SFD/SMD-Cx DETECTION

NOVEMBER 2015

AUTOMOTIVE NETWORK COMMUNICATION PROTOCOL

BEHAVIOR ACCORDING TO 802.3-2012

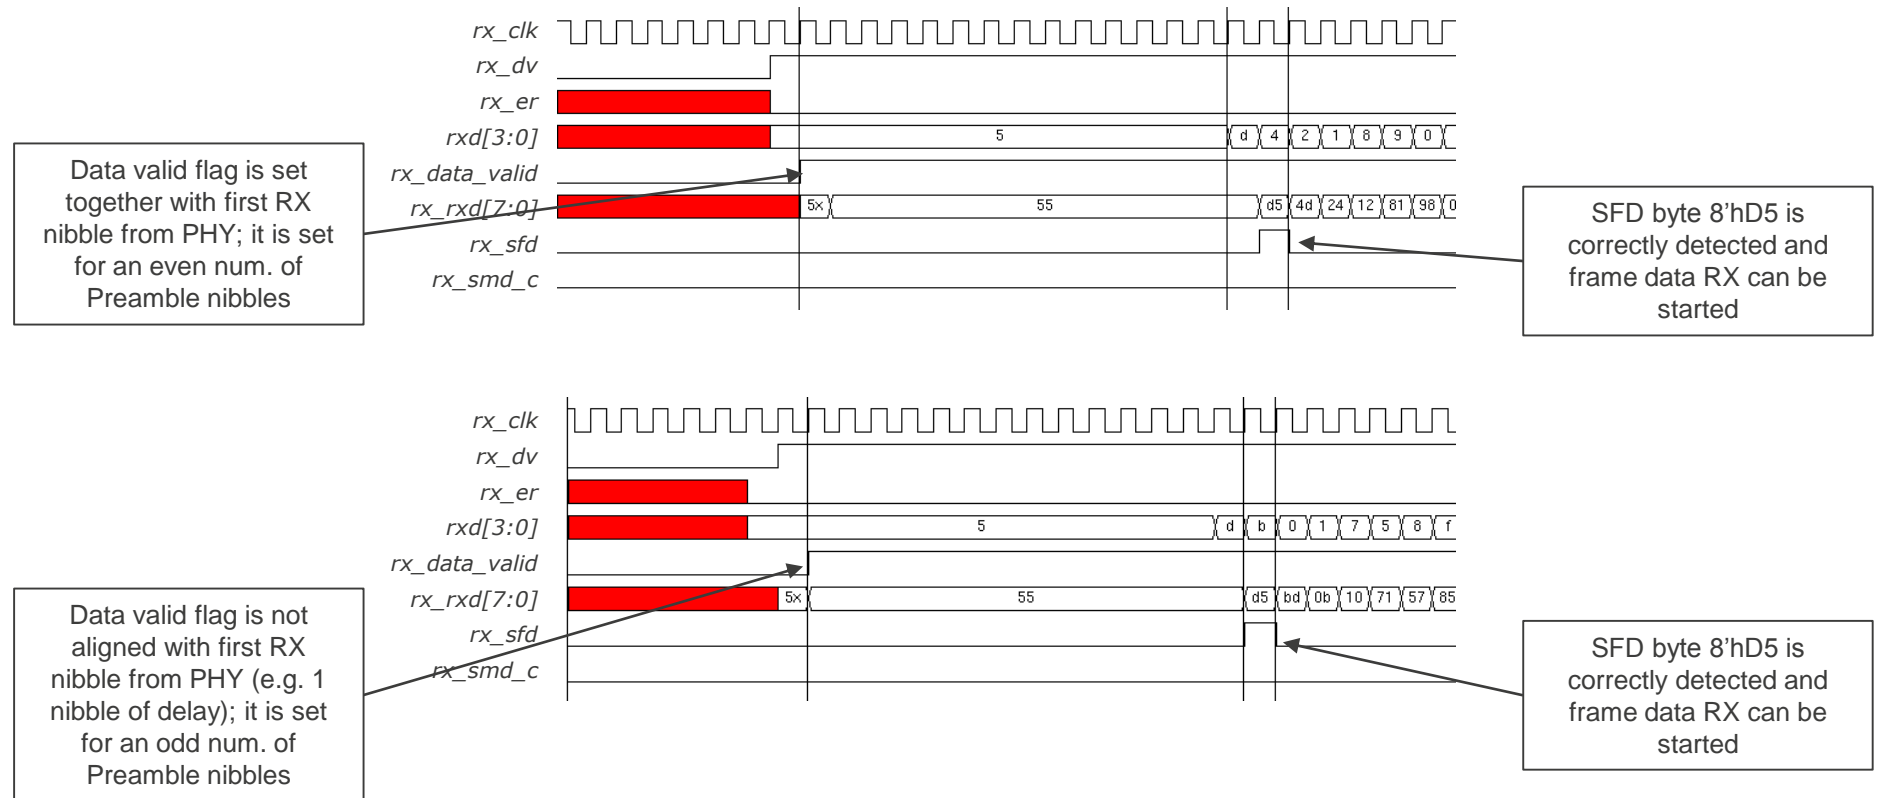
Usually MII implementation do not count the received preamble nibbles it just try to recognize the SFD filed 0x5D

- The interface is able to identify SFD byte 8'hD5 at each new nibble received from PHY interface once the data valid is set to 1'b1

Table 99–1—SMD values

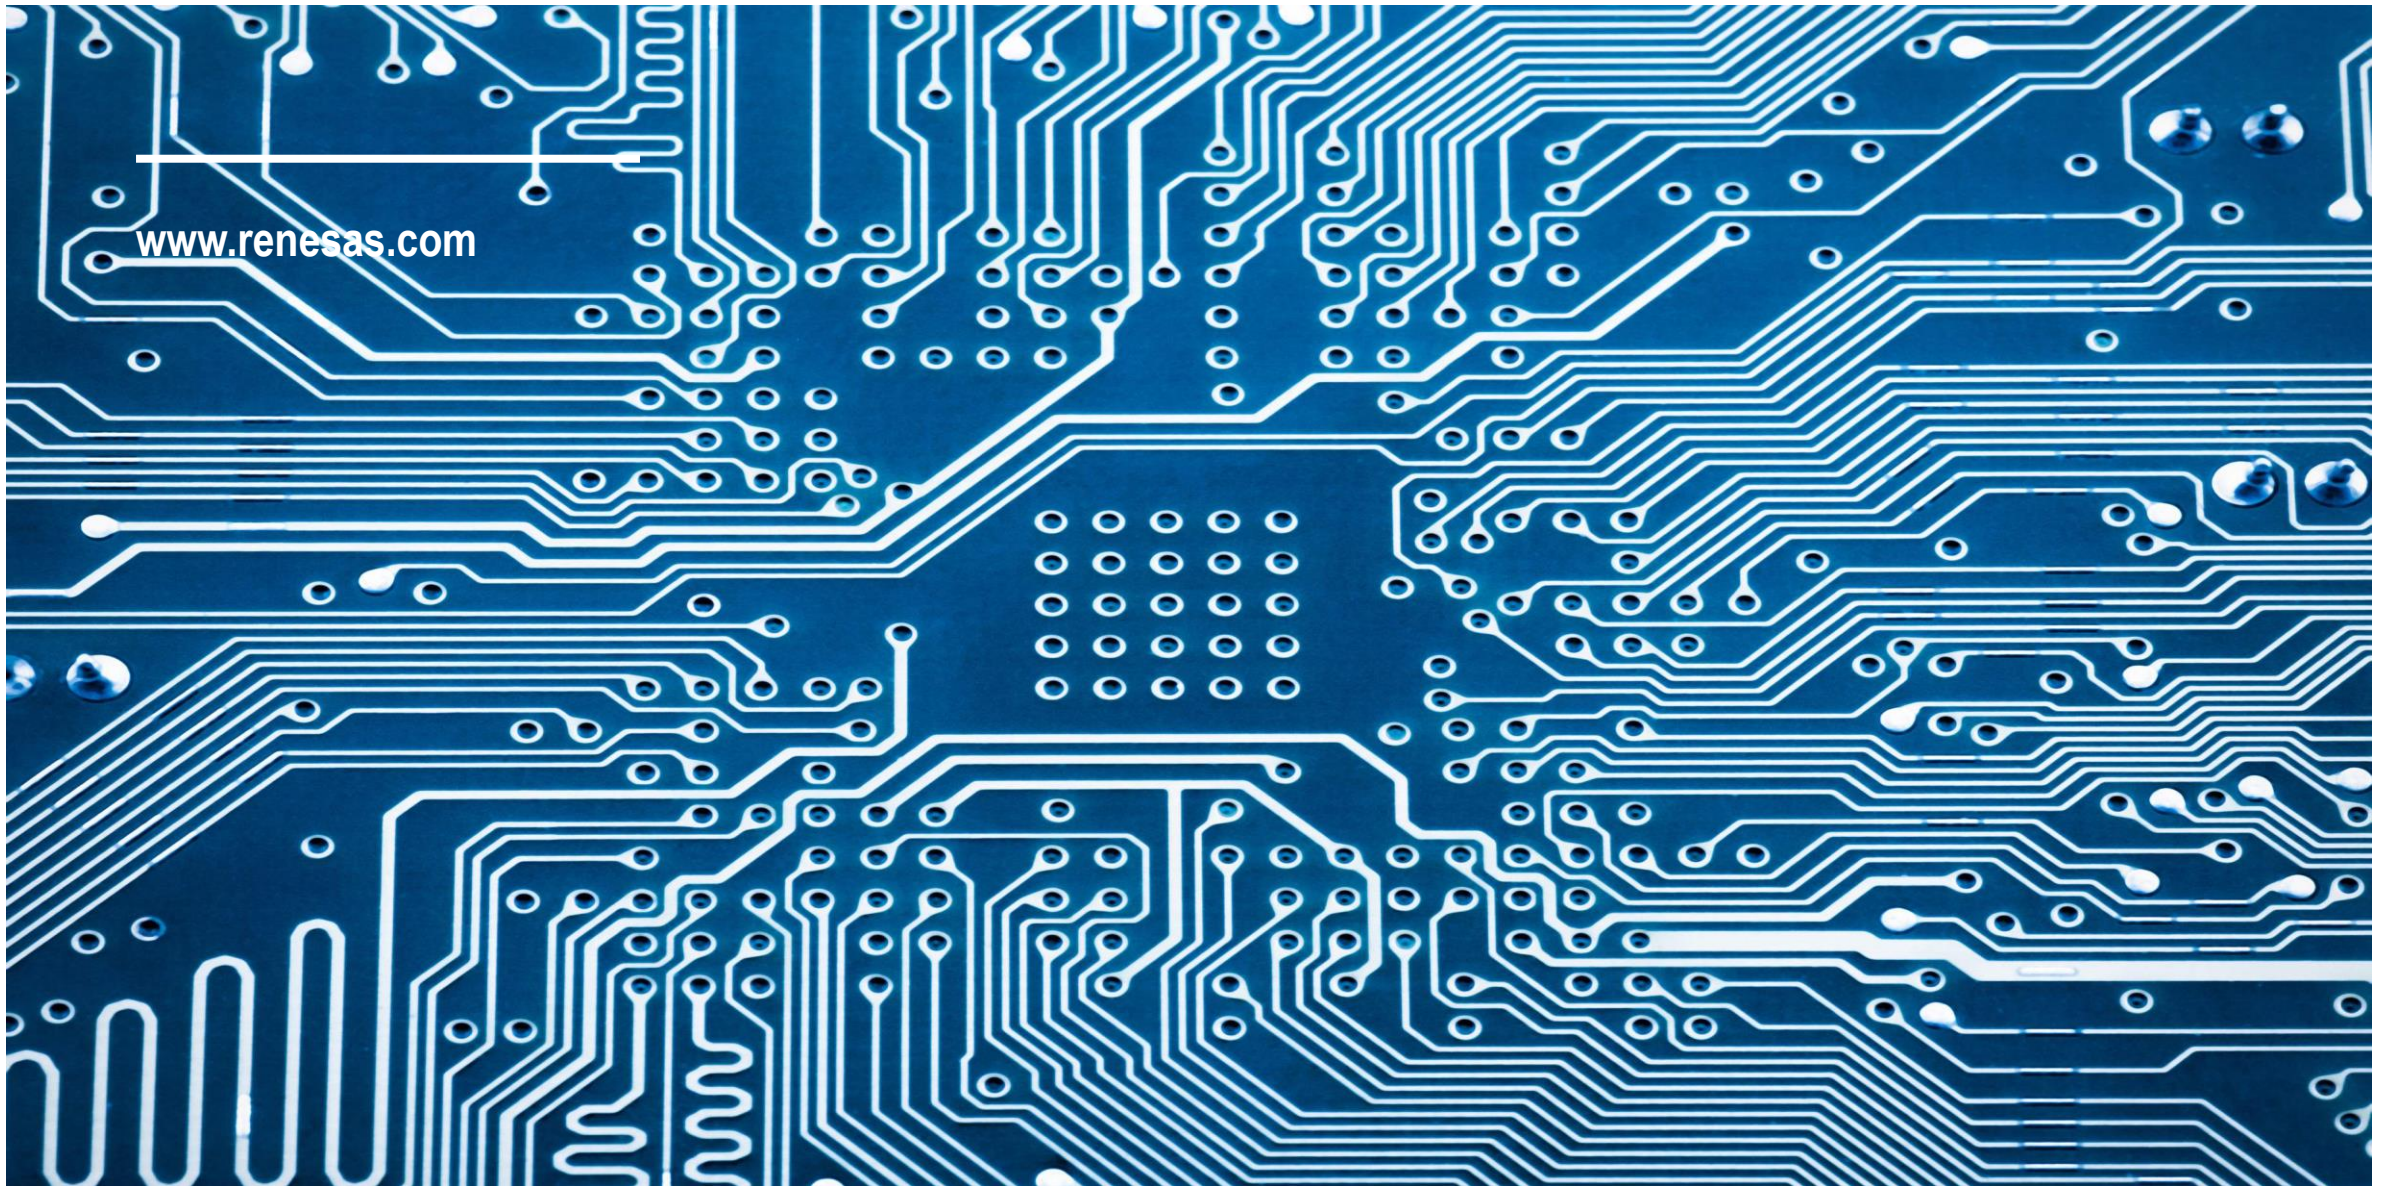
The problem occurred due to the encoding of the “D” in the byte of the SMD-C3 as consequent a continuation fragment with SMD-C3 will never be transferred, as the frame is interpreted as express frame with 0x5D

- The misinterpretation of the SFD will result to invalid FCS (mCRC)

The problem will not occur with the other encoding values like SMD-S0, SMD-S2, SMD-C1 etc.

Therefore our proposal would be to change the encoding value of SMD-C3 different than 0x?D
